CLAREMONT BUSINESS PARK 2 FILING NO. 2

CONSTRUCTION PLANS

FEBRUARY 2023

EL PASO COUNTY FILE NO. VR233

8/11/11	Typical Cross Pan Layout Detail Standard Drawing		
DATE APPROVED: André P. Brackin	REVISION DATE: 12/8/15	FILE NAME: SD_2-26	
DEPARTMENT OF TRANSPORTATION

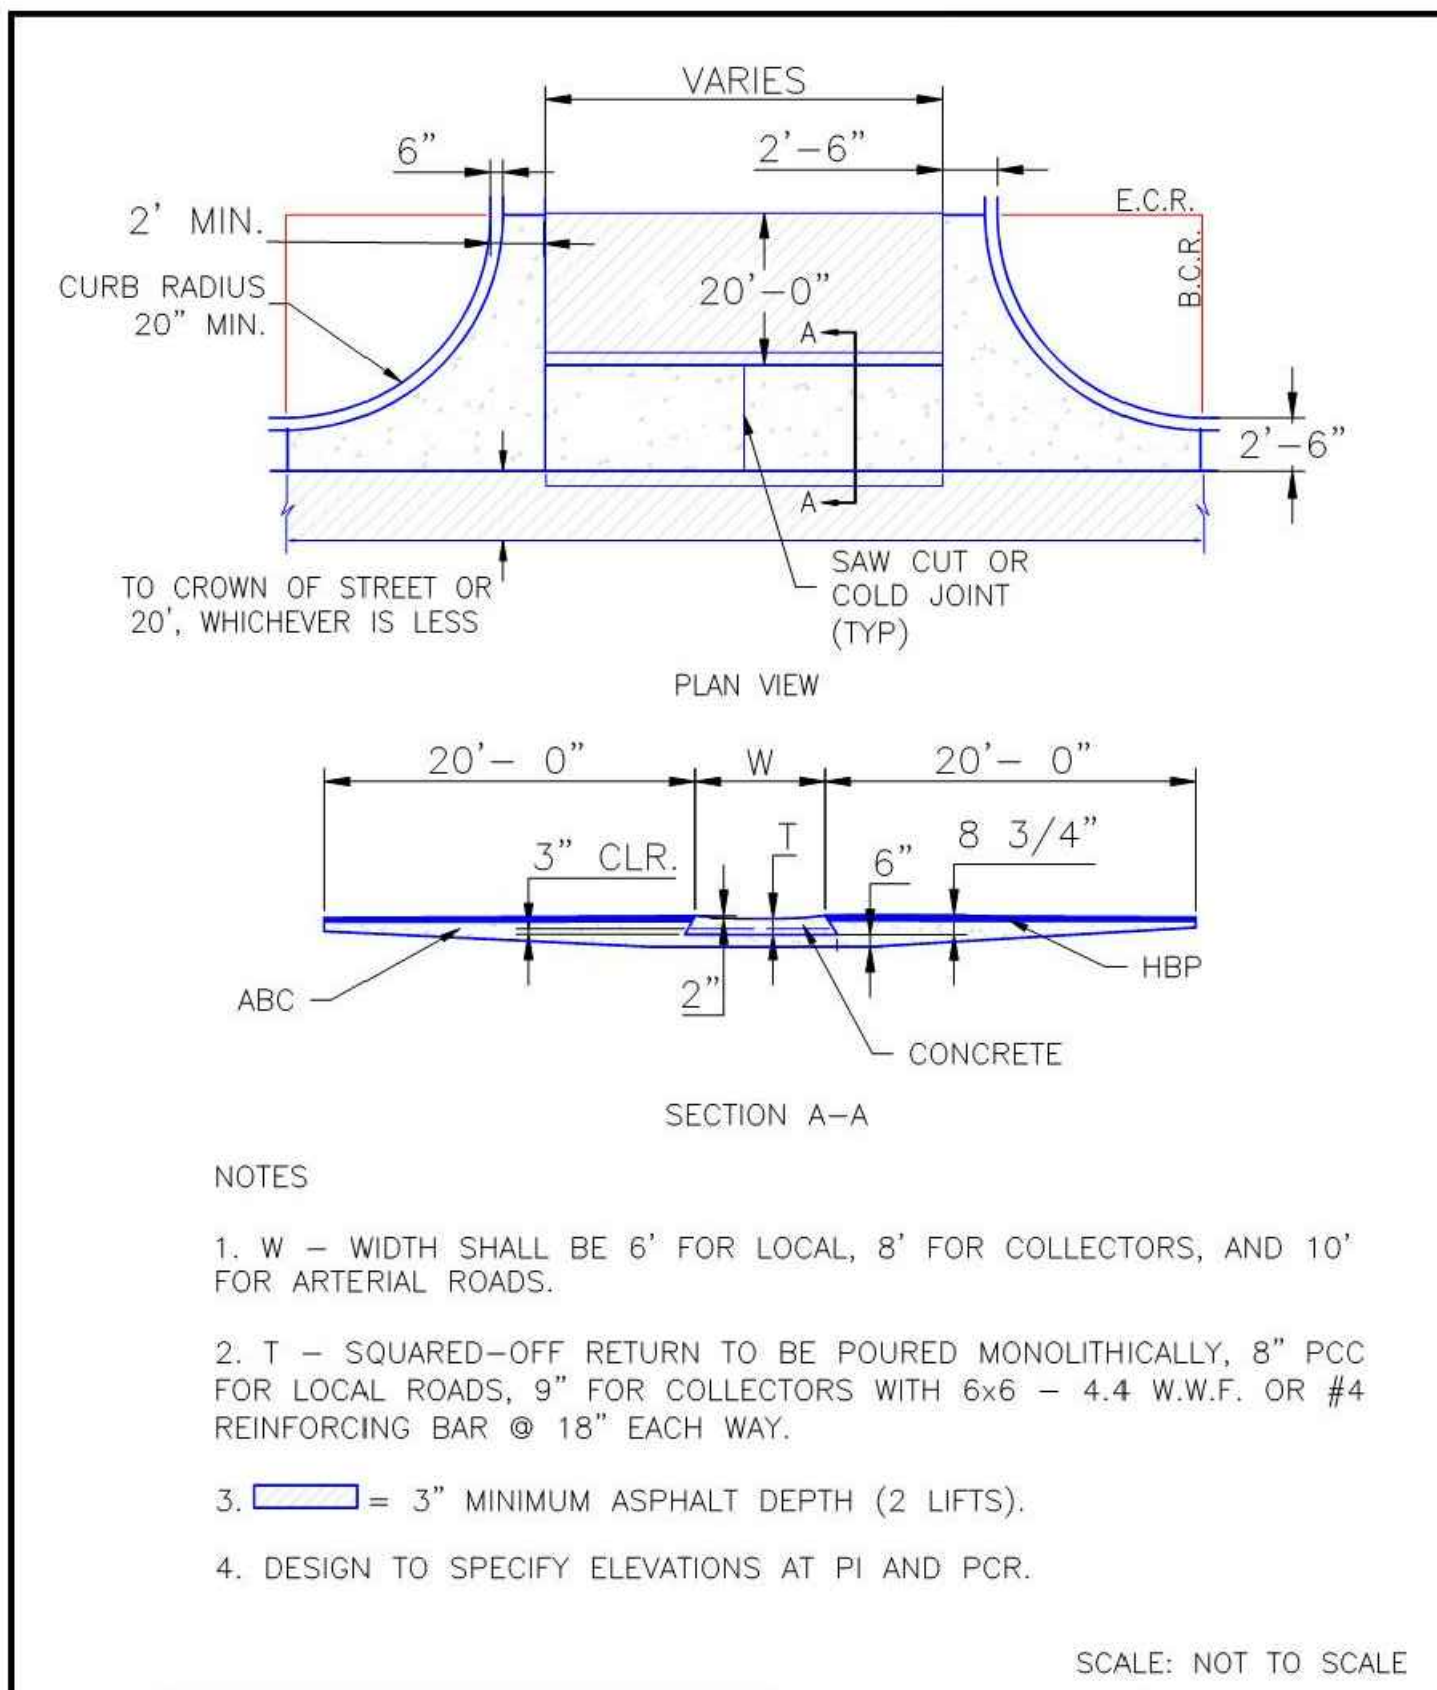
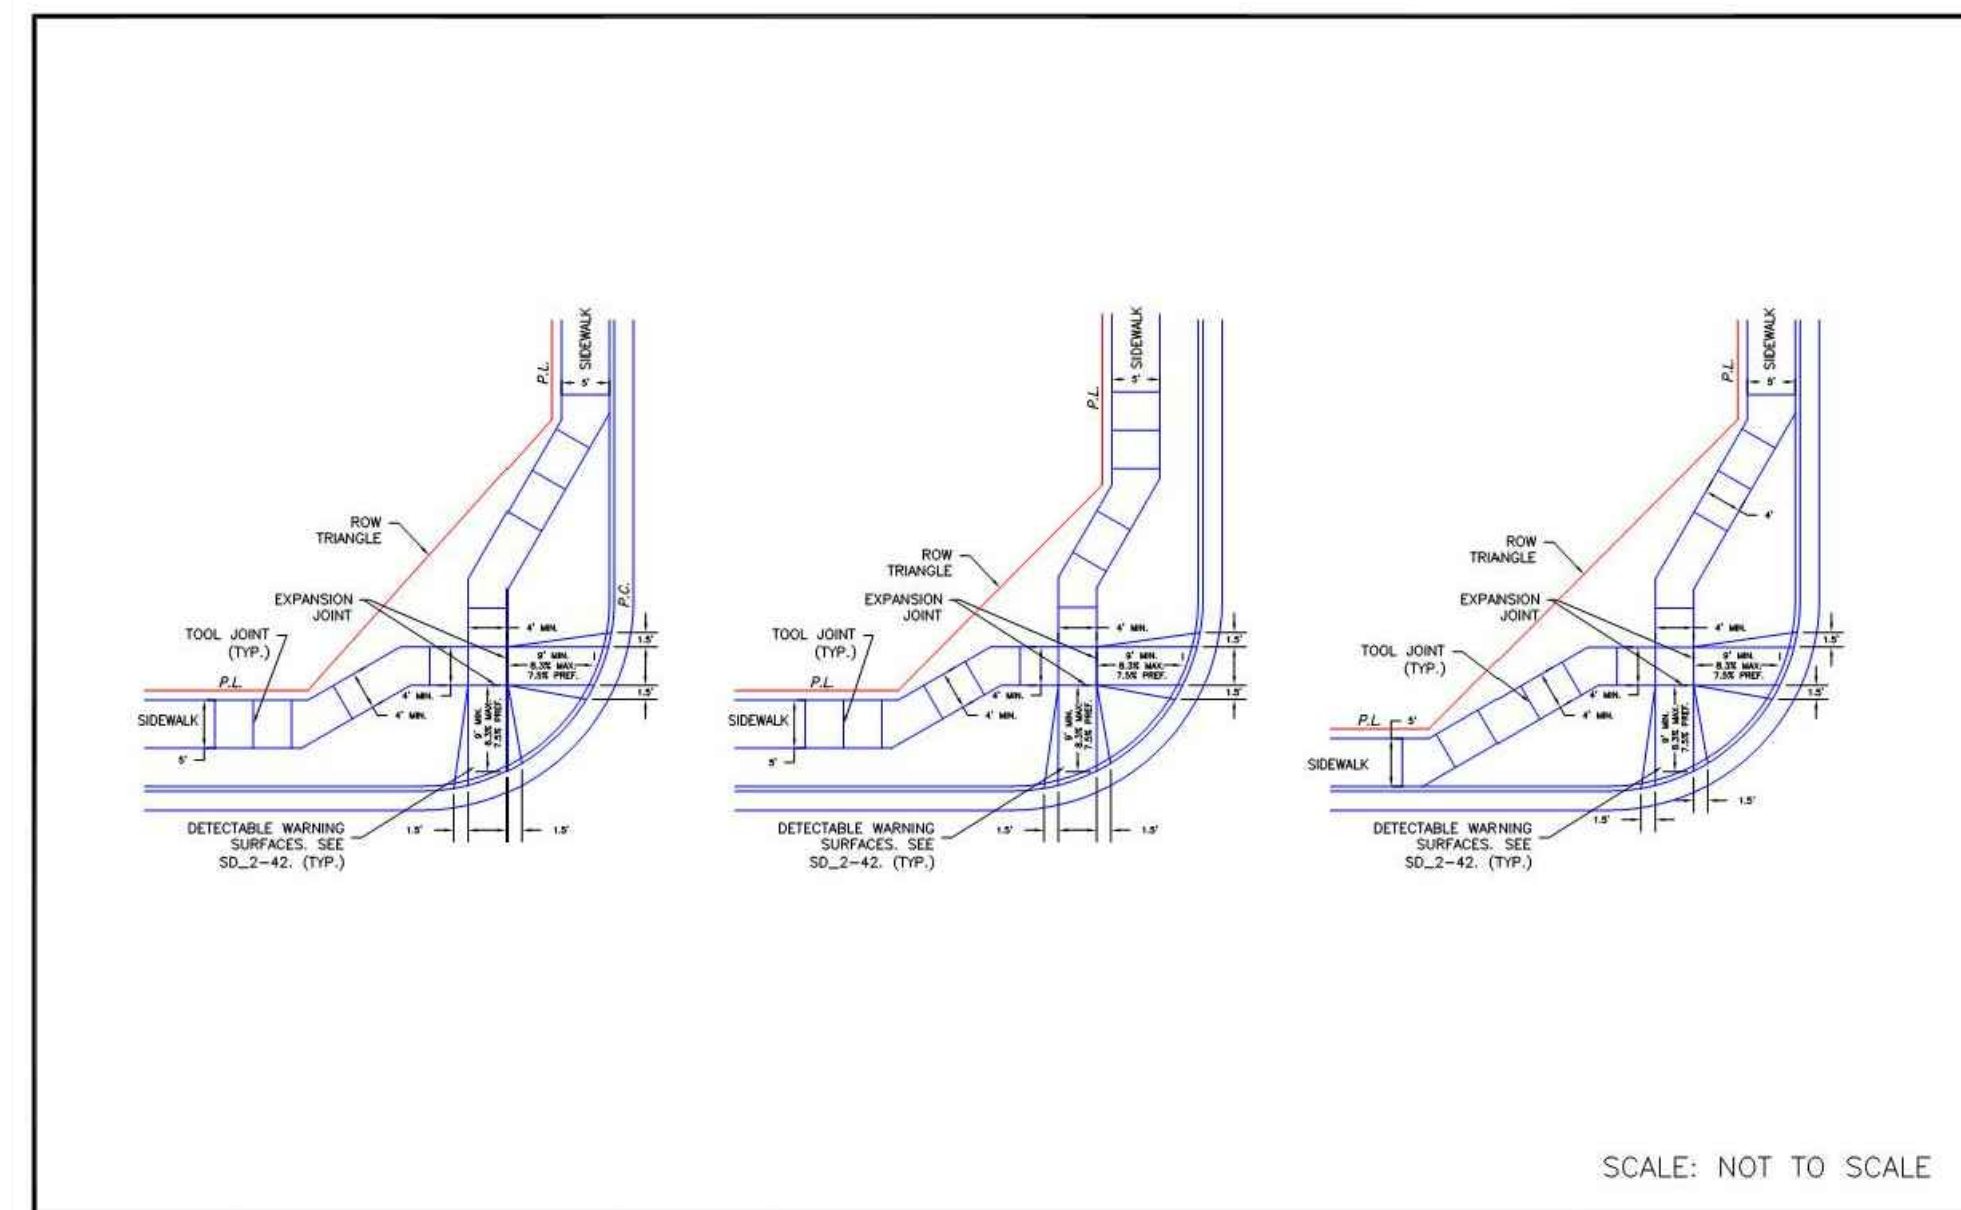
Please add El Paso County Standard Detail SD_2-24 Driveway Detail with Attached Sidewalk

STORM SEWER PLAN & PROFILE

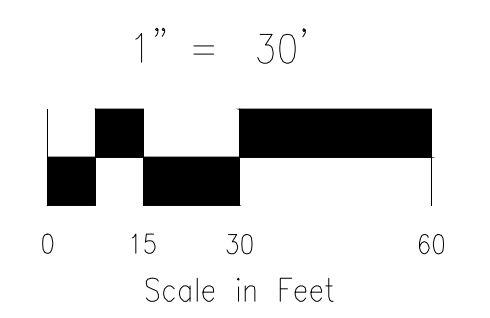
Missing structure

MAINTENANCE & ACCESS ROAD ABOVE EURV TYPICAL SECTION
NOT TO SCALE

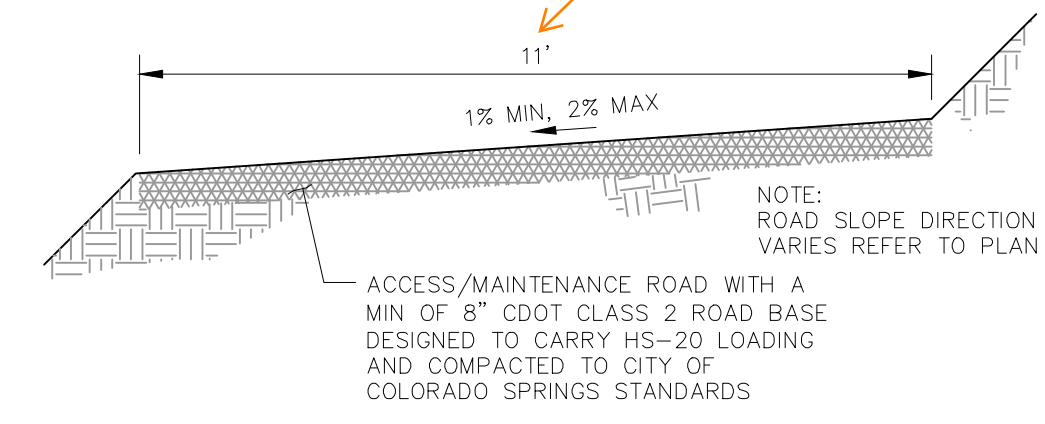
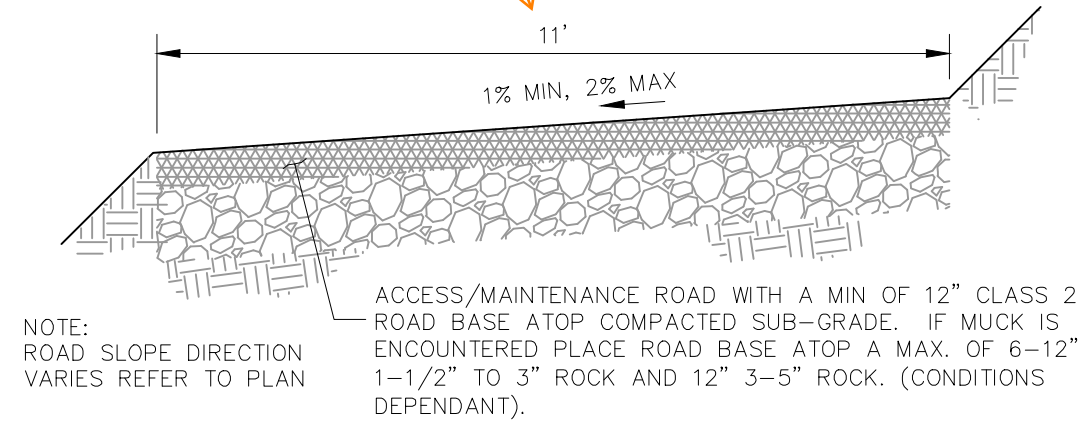
Plan dwg on next page show width of access road at ~30ft. Revise to remove discrepancy.
Stabilized access ramp shall be a minimum of 15ft wide and no greater than 12% slope, in accordance with DCMv1, Chap 11.2.2. As I think you know, it may be acceptable to design the access road with a thinner width if the anticipated maintenance vehicles and equipment can still safely access the pond and reach structures. Properly document this in the Pond O&M manual.

LOT 2 - SAND FILTER POND 3
SITE PLAN
 SCALE 1"=10'

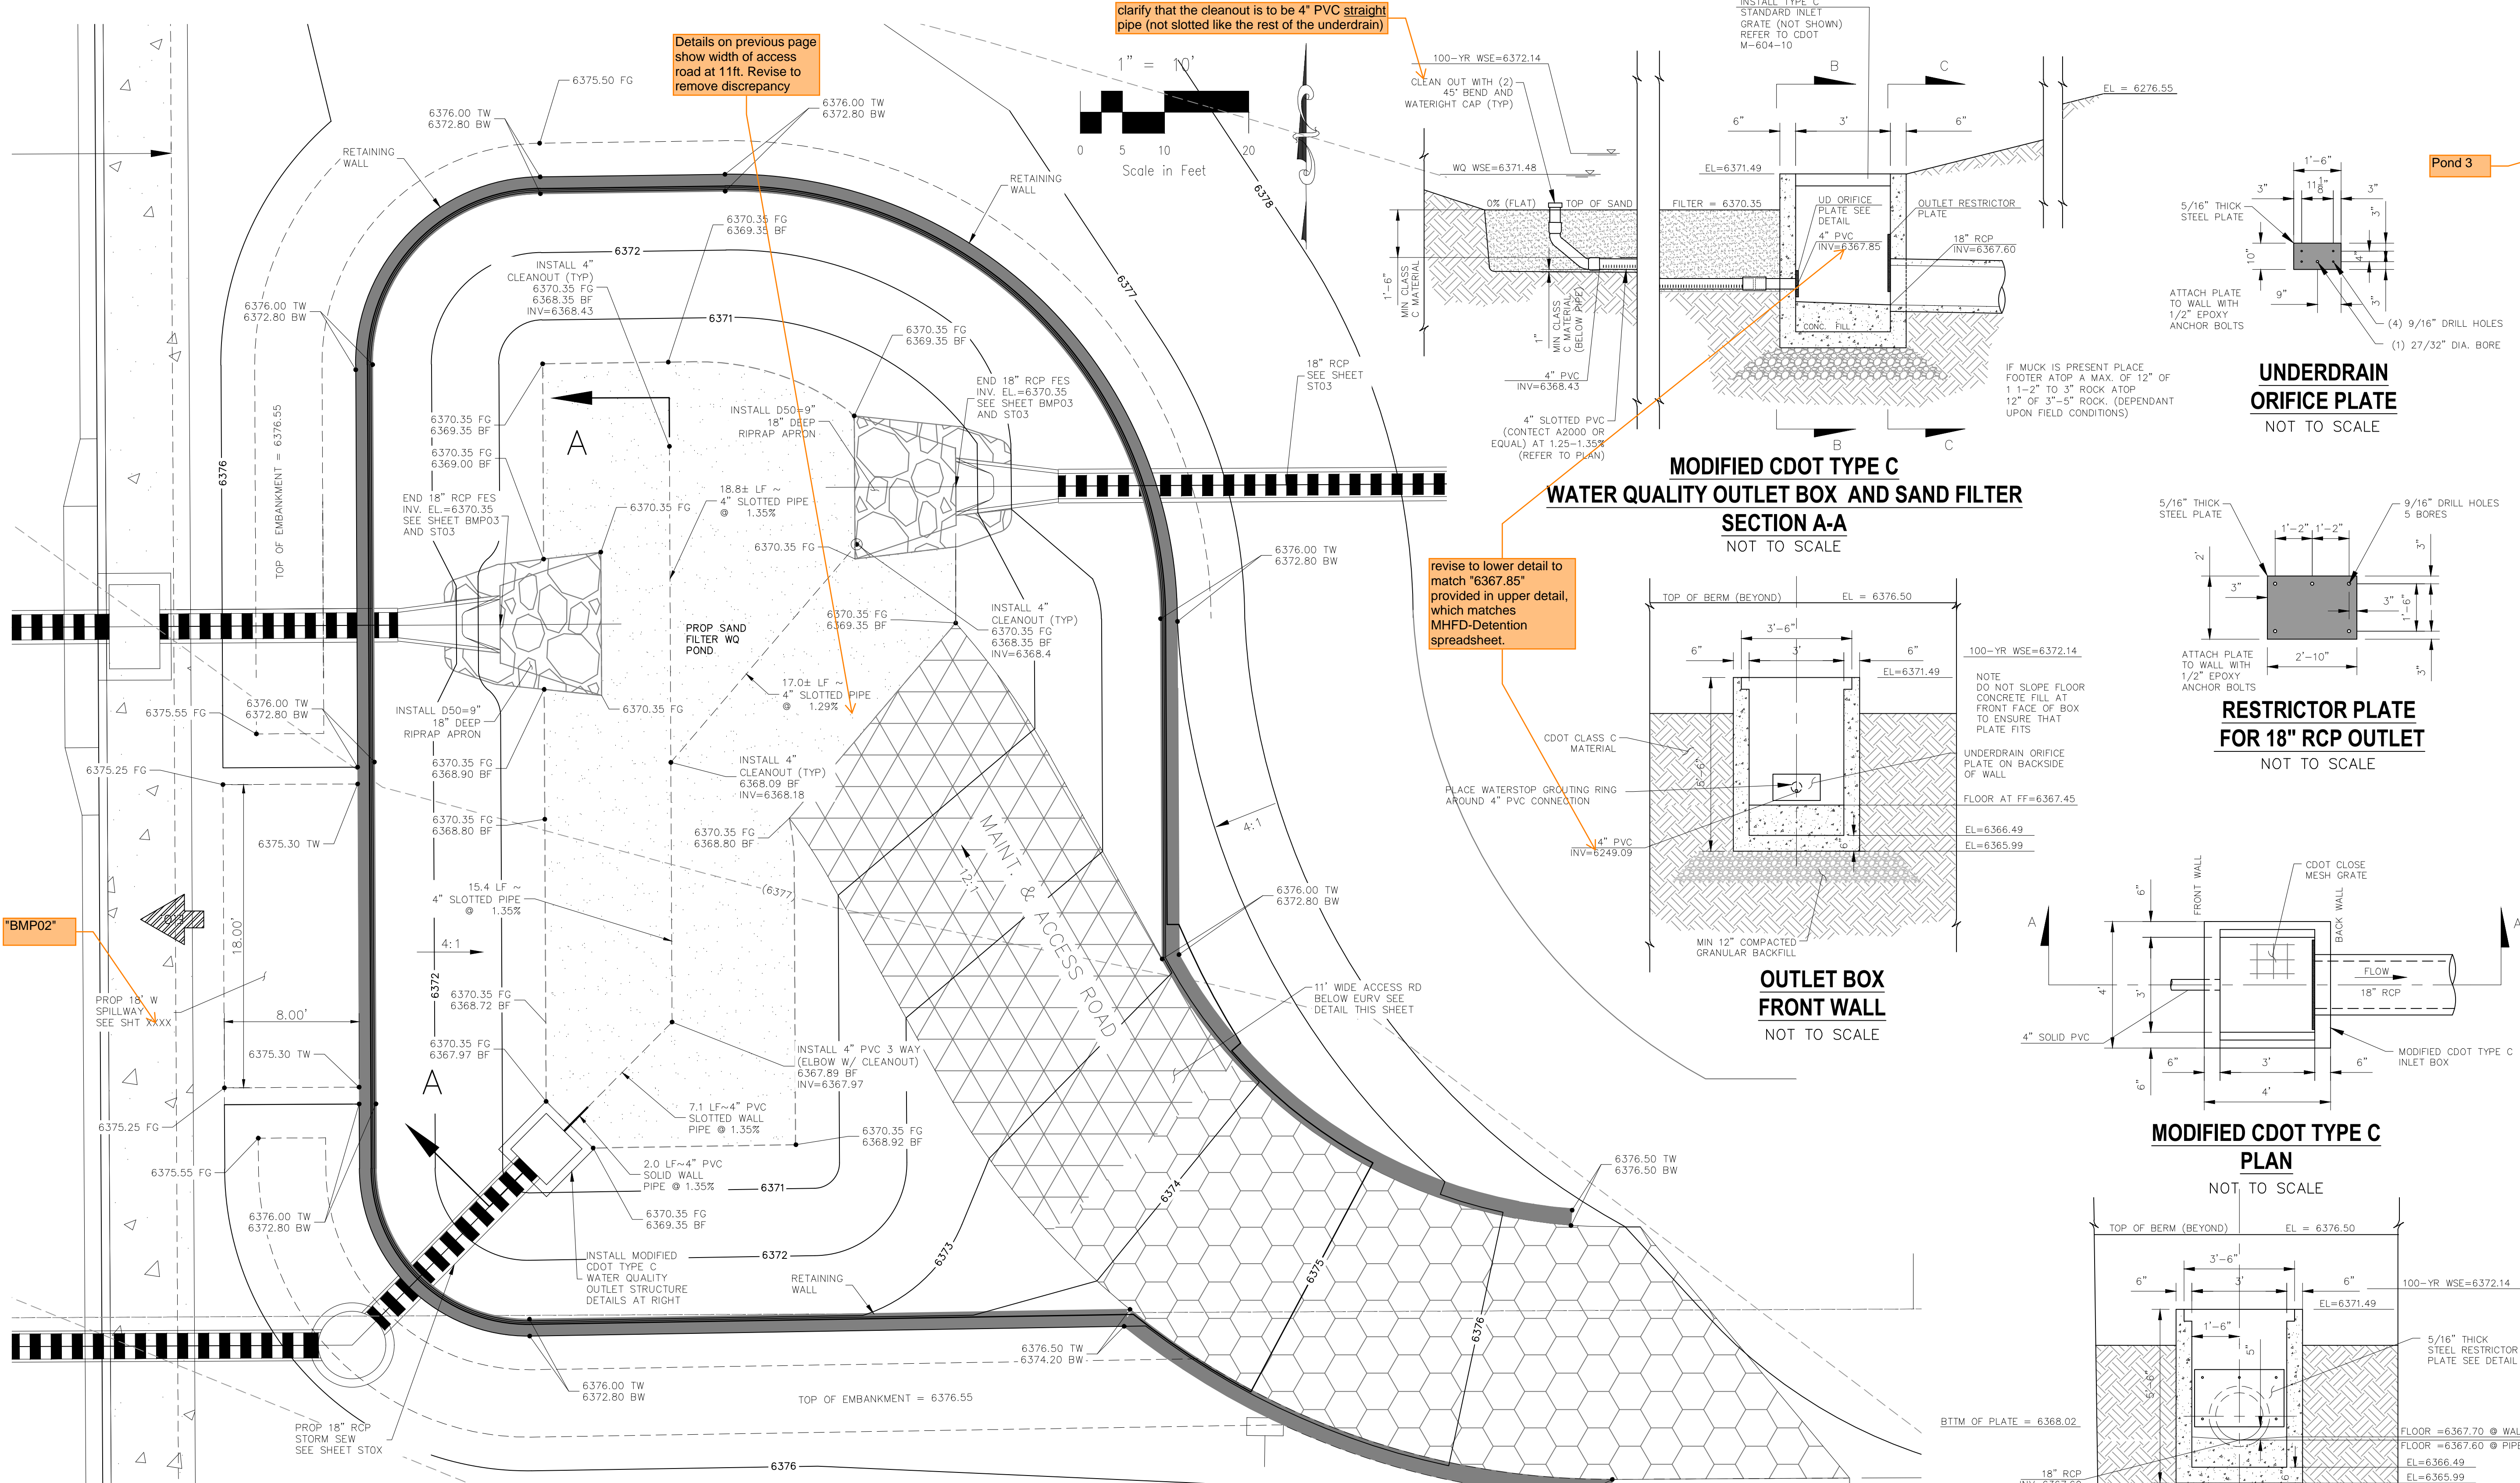
Details on previous page show width of access road at 11ft. Revise to remove discrepancy

MODIFIED CDOT TYPE C
WATER QUALITY OUTLET BOX AND SAND FILTER
SECTION A-A
 NOT TO SCALE

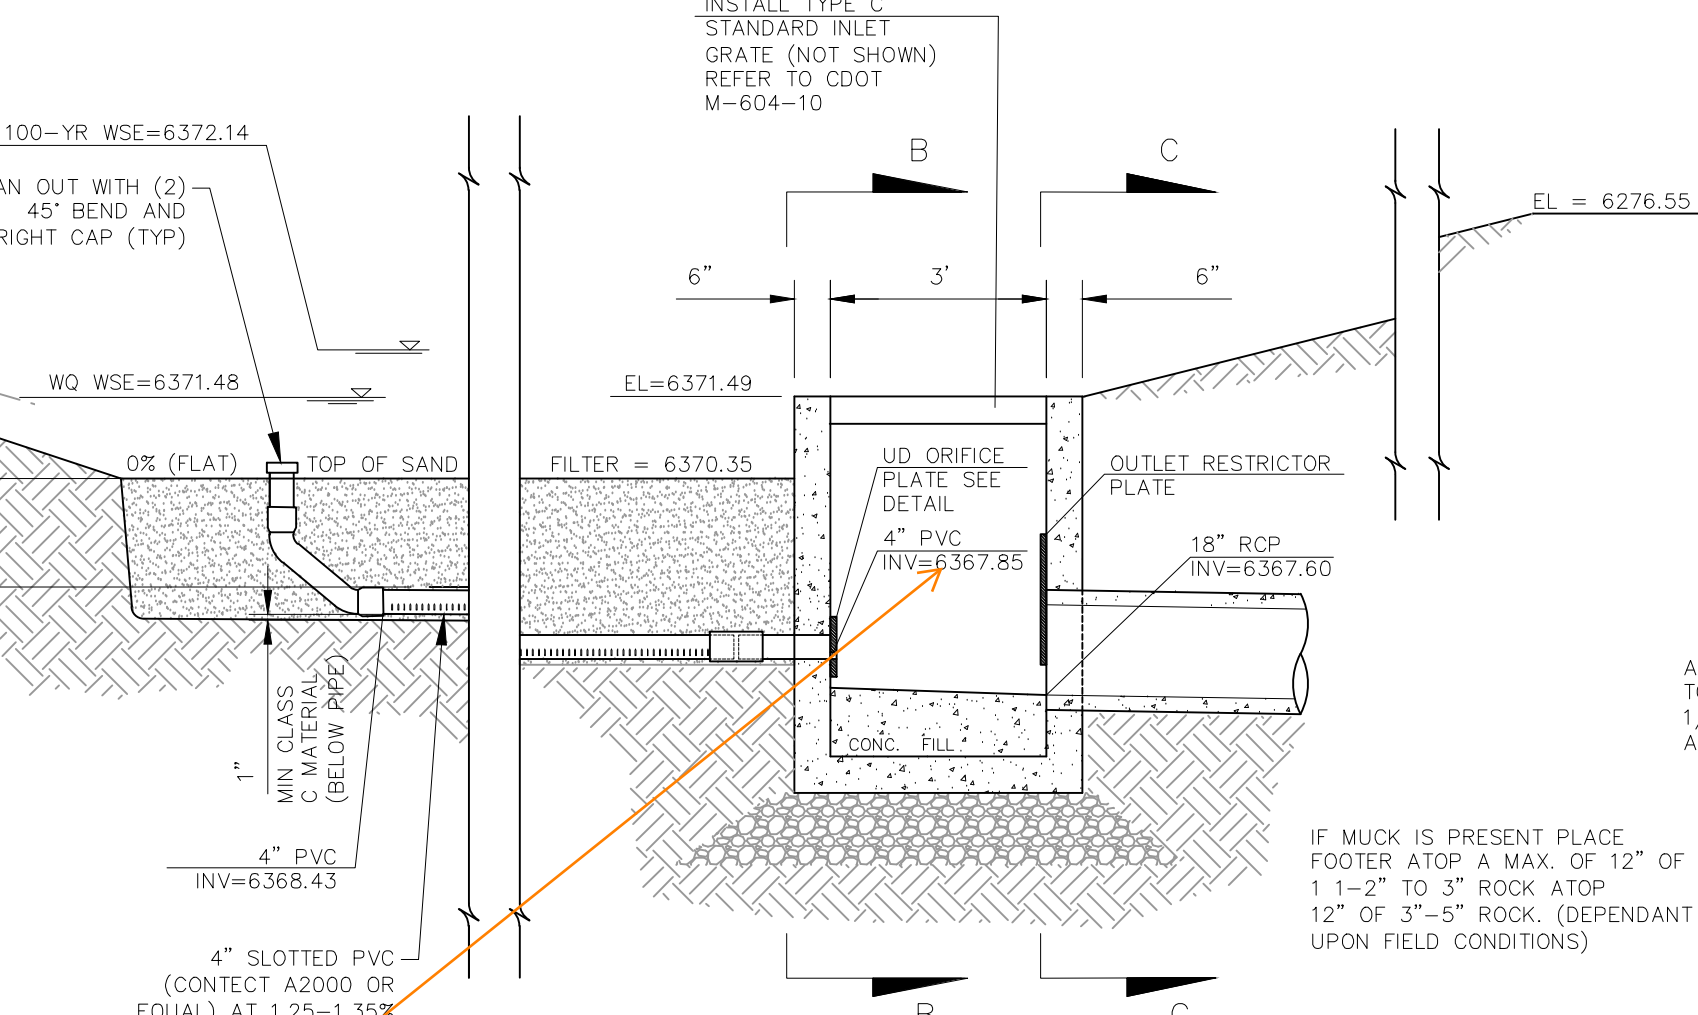
revise to lower detail to match "6367.85" provided in upper detail, which matches MFD-Detention spreadsheet.
